Pre-Application No. 720130060 - Ten Mile Creek

Pre-Application No.

Staff Recommendation: Object to the submission of a preliminary plan

SUBJECT: Ten Mile Creek Pre-Preliminary Plan 720130060 Pulte Homes

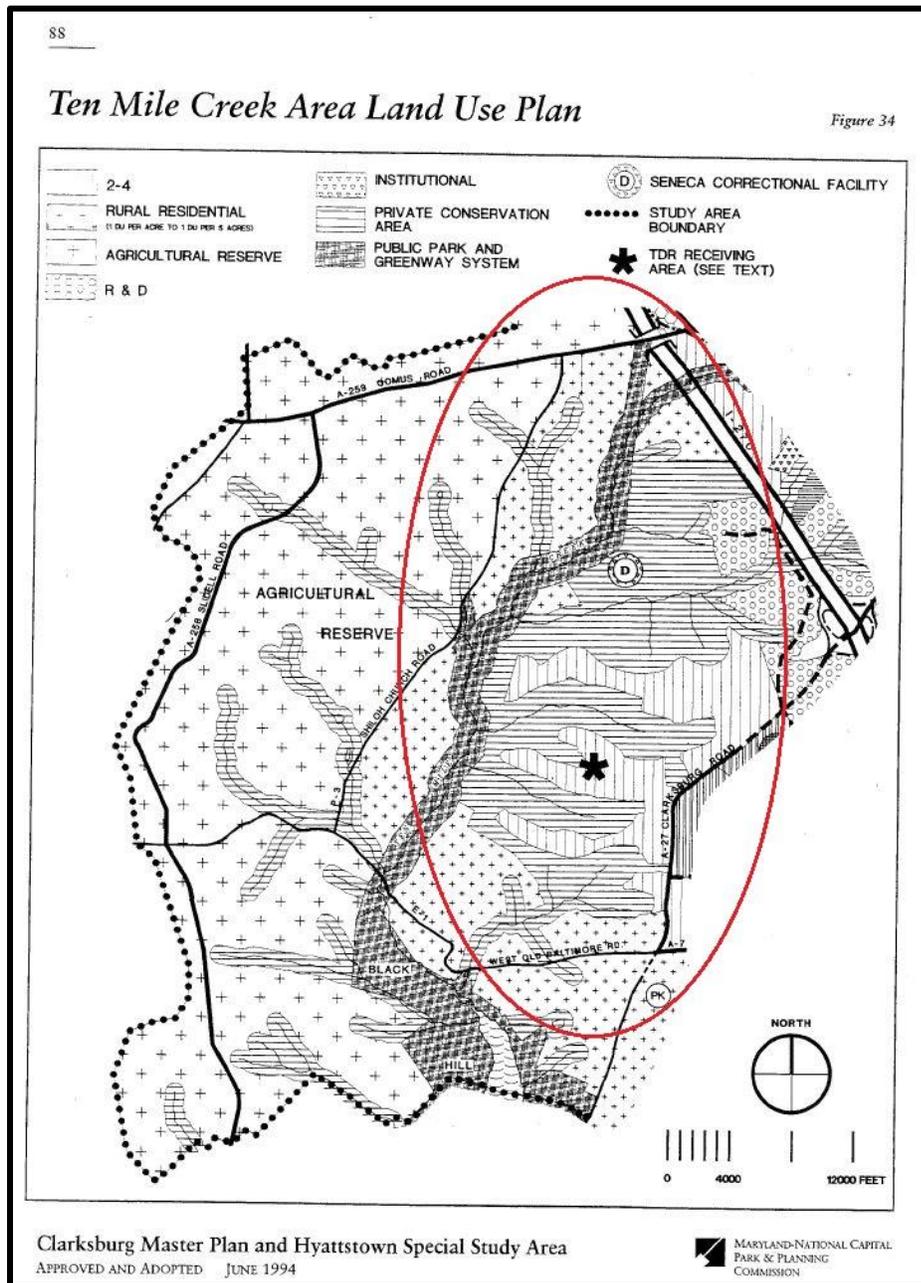
To conclude, the illustration above clearly shows that the proposed development encroaches into the Private Conservation Areas. The Master Plan specifically states that these areas should remain undeveloped and reforested. For this reason, staff has recommended that the plan must be revised to avoid disturbance to the Private Conservation Areas. The number of proposed units does not substantially conform to the maximum number of units recommended for the 593 acre TDR receiving area. In addition, Staff has highlighted other issues that must be addressed at the time of preliminary plan including: water and sewer category changes, context sensitive road design standards, building orientation, traffic studies, coordination of future roads, and views into stream valley buffers. All of these considerations may affect the total number of lots that can be accommodated on the Subject Property.

- Development of the property must avoid disturbance to the Private Conservation Areas shown on the Ten Mile Creek Land Use Plan of the Clarksburg Master Plan.

Figure 1. 1994 Clarksburg Master Plan and Hyattstown Special Study Area - Ten Mile Creek Land Use Plan

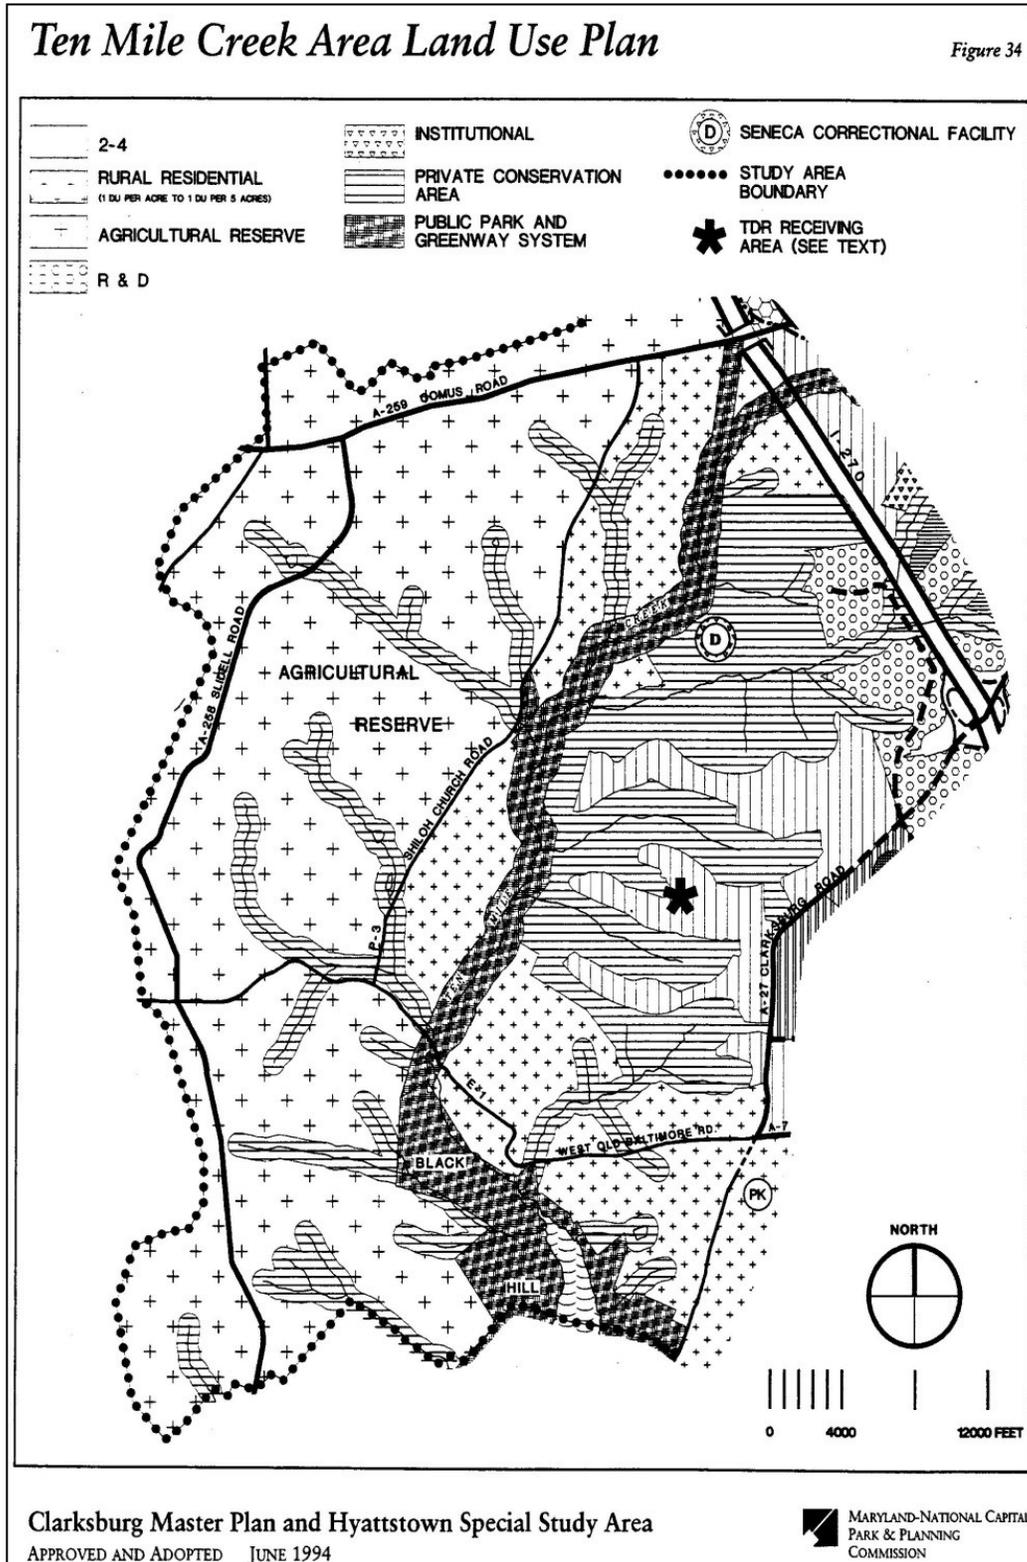
Department of Parks staff recommends a 362 acre park dedication as part of the Ten Mile Creek Pre-Preliminary Plan (720130060) in Clarksburg. This dedication matches the areas identified for “public park and greenways” and areas identified for “private conservation areas” in the approved and adopted 1994 Clarksburg Master Plan and Hyattstown Special Study Area (Figure 1).

Department of Parks staff recommends that the areas shown in the 1994 plan as “public park and greenways” and the areas shown as “private conservation areas” be dedicated as public parkland as part of this development project.
